UNITED STATES PATENT AND TRADEMARK OFFICE

APPLICATION NO.	FILING DATE	FIRST NAMED INVENTOR	ATTORNEY DOCKET NO.	CONFIRMATION NO.
10/726,760	12/03/2003	Thomas Kocmer	DKT02164	4211

Office Action Summary

DETAILED ACTION

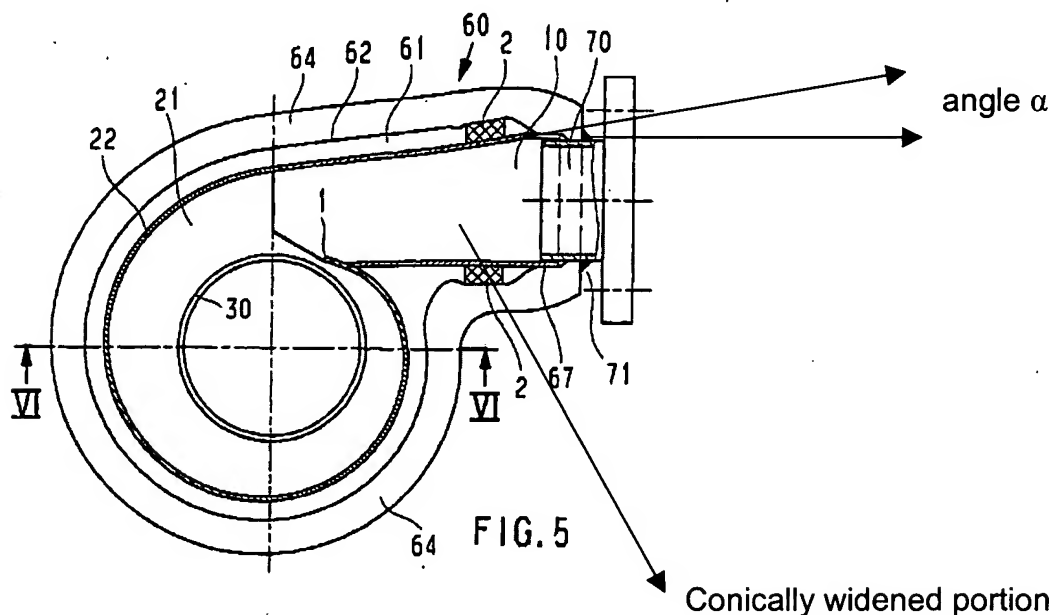
Manfred teaches that it is conventional in the turbocharger art, to utilize said heat conductive connection being formed between first and second tubular elements by a conically widening portion (10) one of the tubular elements, followed by a cylindrical portion into which the tubular end of the respective other element, the tubular connection element (70), inserted, the conically widened portion advantageously having an angle (α) of at most 30° , of at most 20° , and at least 7° and whereby the inner surface the cylindrical portion abuts onto the outer surface of the tubular end of said respective other element, wherein one of said tubular elements is the housing and the other of said tubular elements is the branch pipe (See attached Figures 2, 5, and 11; Column 4, lines 52-58, and Column 5, lines 32-36); and

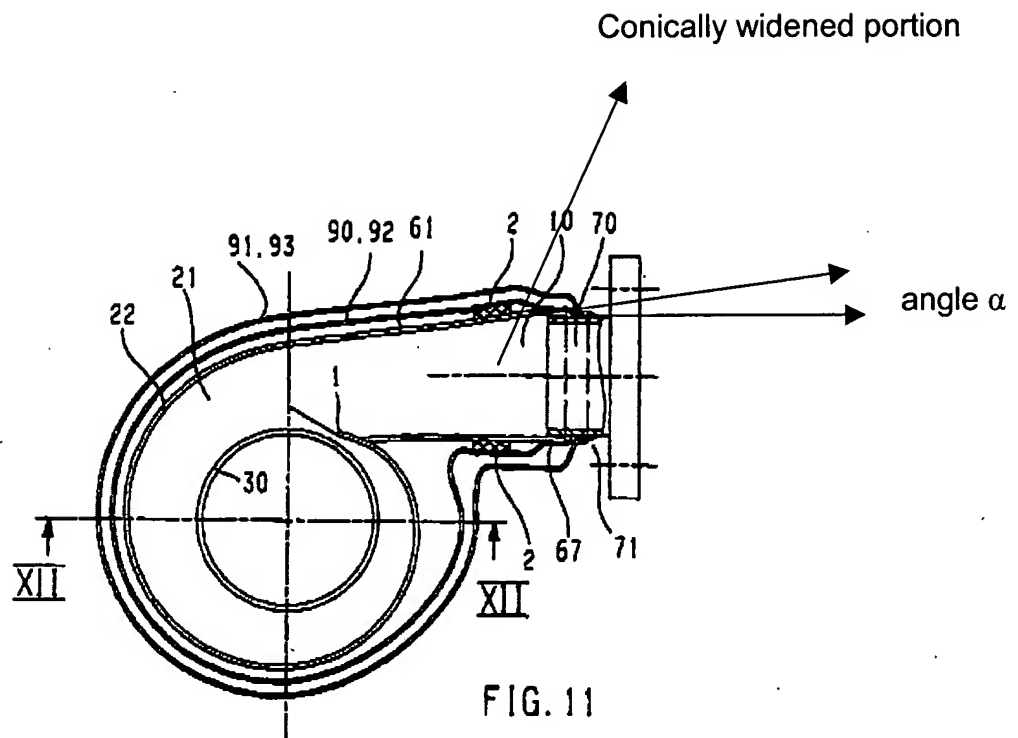
said heat conducting connection comprising a cylindrical portion (See attached Figure 5) of one of the tubular elements, into which the tubular end of the respective other tubular element is insertable, wherein the inner surface of the cylindrical portion abuts onto the outer surface of the branch pipe (70) (See attached Figures 2, 5, and 11; Column 4, lines 52-58, and Column 5, lines 32-36);

said housing (22, 23, 62, 63) consisting at least two layers of metal sheet arranged one outside of the other, wherein the outer one (60, 62, 63) is thicker than the inner one (22, 23) (See attached Figure 5); and

Note that from the Figures 5 and 11 of Manfred, the angle (α) is to be in the range of at most 30° , of at most 20° , and at least 7° , as applicant claims in claims 4, and 11-12.
